ADDENDUM NO. 1

Addendum to City of Bryan Request for Bid No. 06-115

“Turkey Creek Trail Sidewalk Improvement Project”

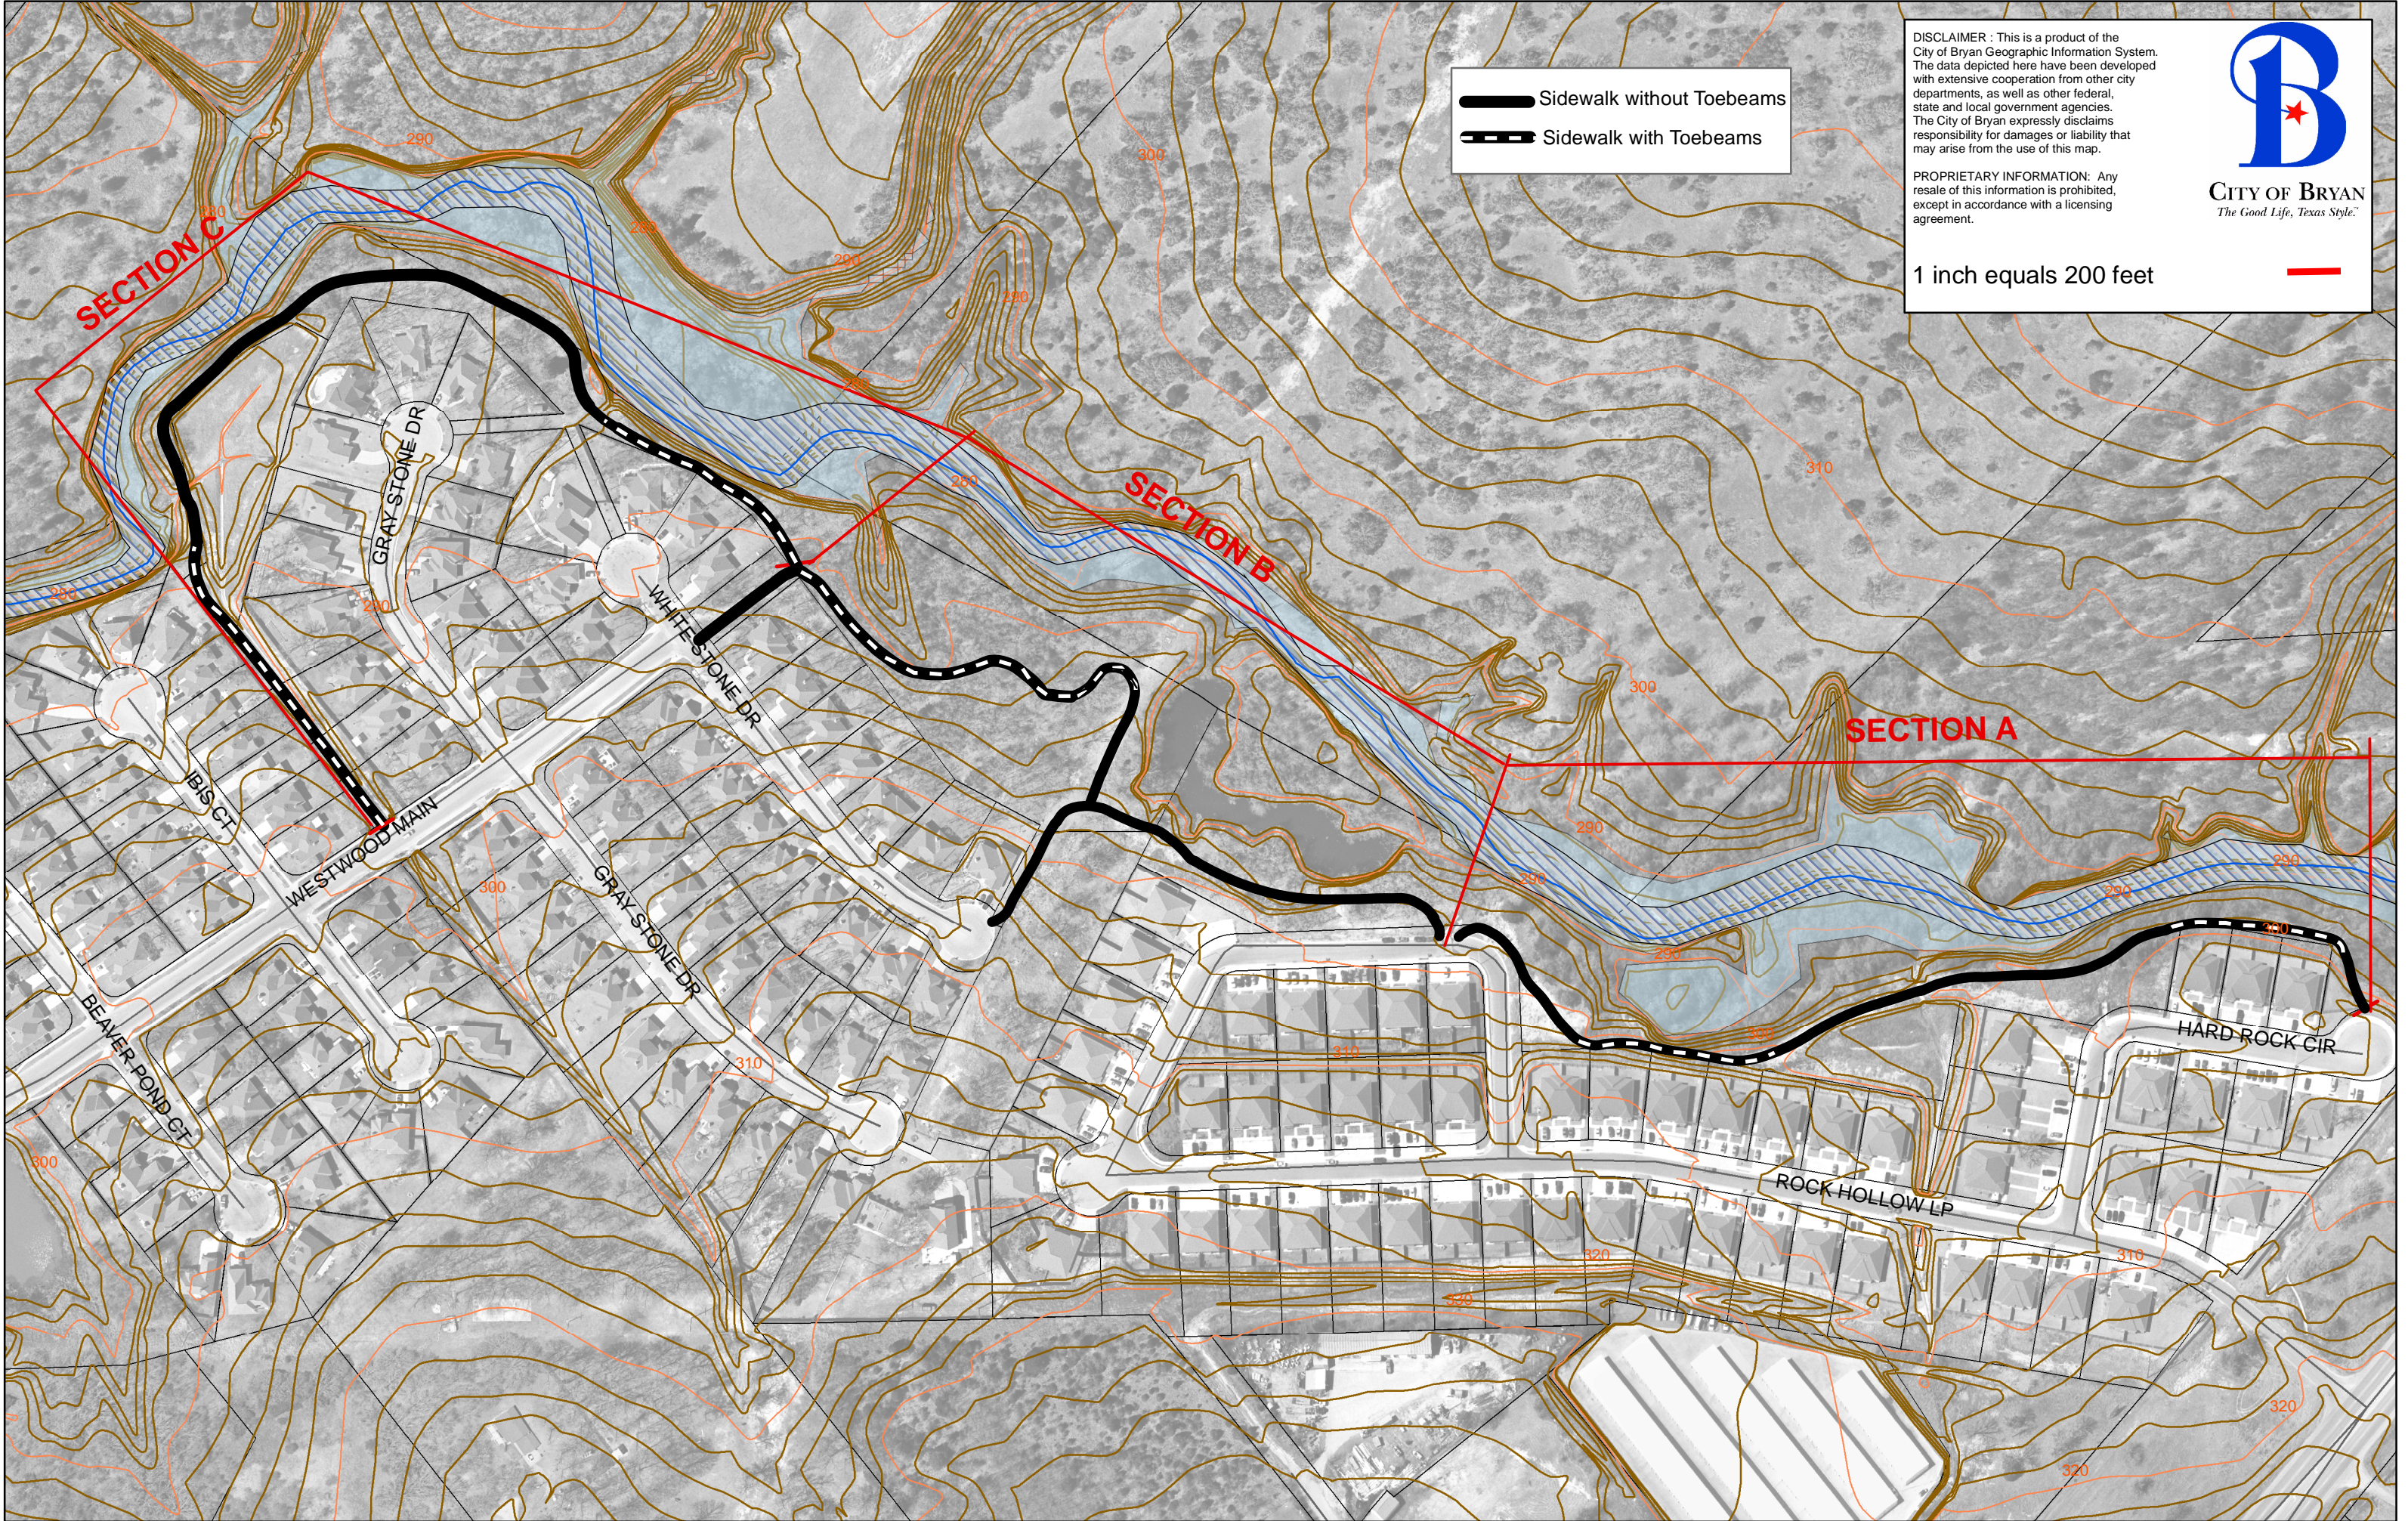
- 1. A new drawing is attached to reflect change in sidewalk layout.**
- 2. The following Technical Specifications have been removed from the documents because they are addressed within the General Provisions.**

- 4. The drawing now shows the areas where the sidewalk will require toebeams. Where toebeams are required they will be 10” deep as measured from top surface of sidewalk, 6” wide and run the length of the sidewalk along both sides . A separate line item has been added for the areas of sidewalk with toebeams . That line item is for construction of the sidewalk (per SY of sidewalk surface) and shall include all costs associated with including toebeams monolithically in the sidewalk construction.**
- 5. Bridges will be constructed at a later date by the city of Bryan. Sidewalk is to stop where designated in the field to allow for bridges in the future.**
